Document name: 221625-EDGE-XX-XX-RP-C-0001_PROPOSED DRAINAGE[P01]

TECHNICAL NOTE FOR 221625 - COLLYHURST VILLAGE

The purpose of this Technical Note is to address the comments received from the Local Lead Flood Authority (LLFA) in relation to the proposed drainage strategy, which forms part of the application for the erection of 168 three and four storey dwellinghouses, and two, five and six storey apartment buildings to provide 76 residential apartments, together with an associated ground floor flexible commercial unit and the creation of a new public park on land bounded by Rochdale Road, Shellard Road, Harrowby Drive, Johnny King Close, Thornton Street North, Stretton Close, and Marston Street, Manchester.

As a result of the revised drainage, the LLFA reviewed the submission and provided the following comments:

Figure 3.1 – Catchment Areas for Surface Water network 2

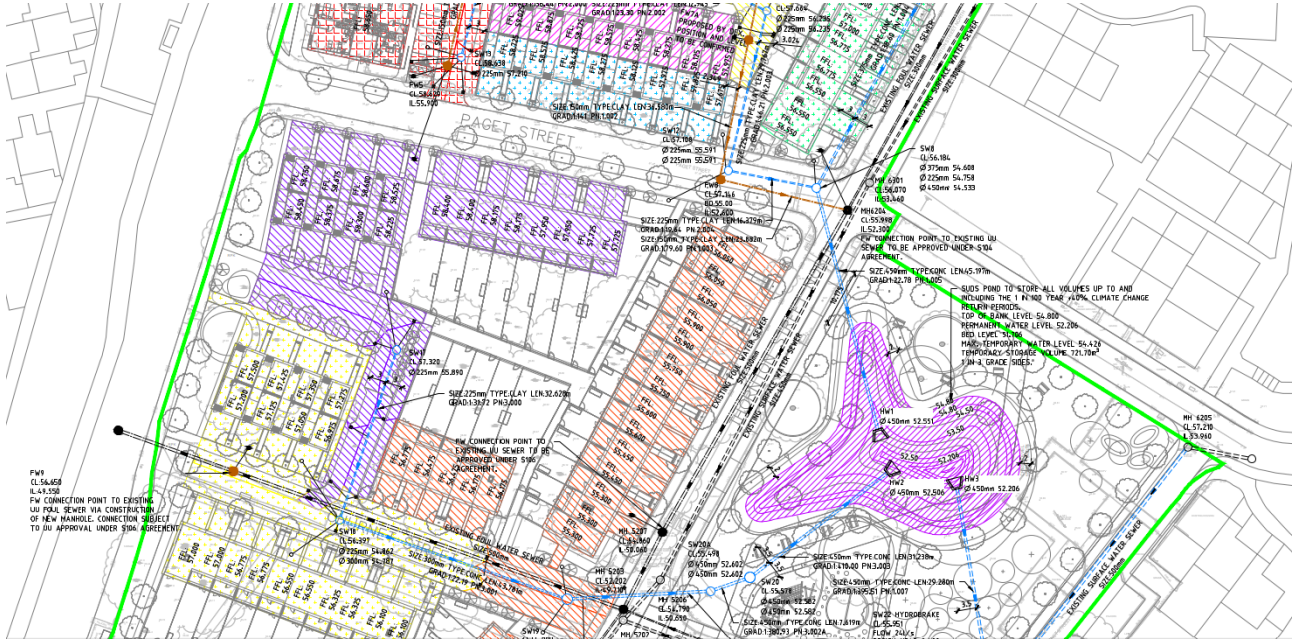
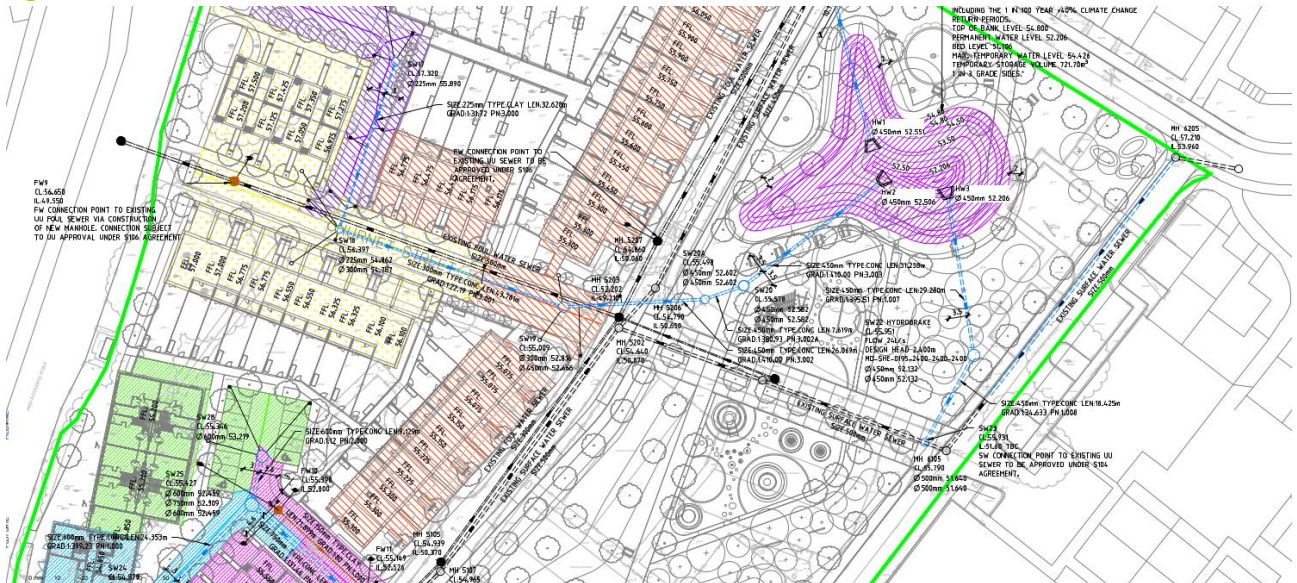
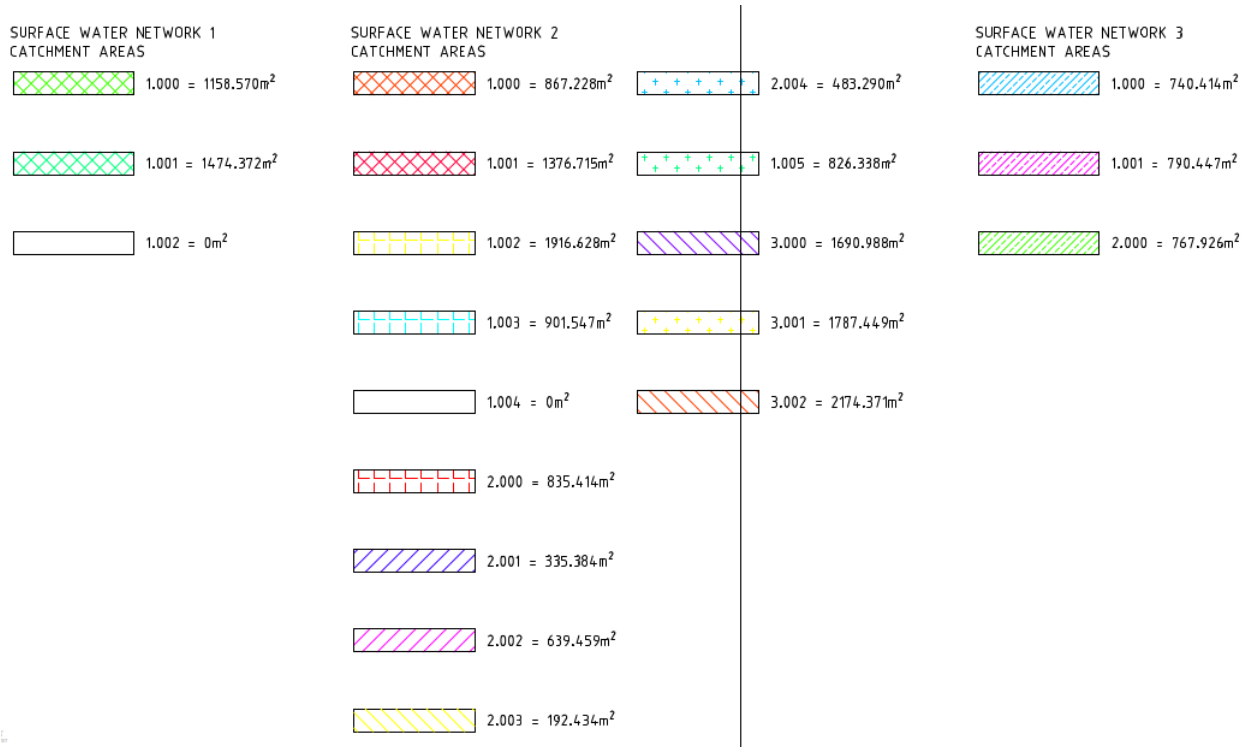
- Please include the attenuation pond within the hydraulic calculations &/or provide updated modelled pond water levels to account for the additional flow into the pond.*
- The Plot Drainage Sheet 1, 2 and 3 drawings (221625-EDGE-XX-XX-DR-C-2010 C07, 221625-EDGE-XX-XX-DR-C-2011 C08, 221625-EDGE-XX-XX-DR-C-2012 C04) do not have manhole reference numbers on the surface water manholes, so it is not possible to cross-reference these with the updated hydraulic calculations. Please provide a layout plan which corresponds with the manhole/pipe references used in the hydraulic calculations (SW1, SW2 etc).*

For further clarification and to address LLFA queries, Figures 3.1 to 3.3 present an overlay of the drainage catchments and drainage layout in this area, assisting in cross-referencing manhole and pipe names with the MicroDrainage calculations.
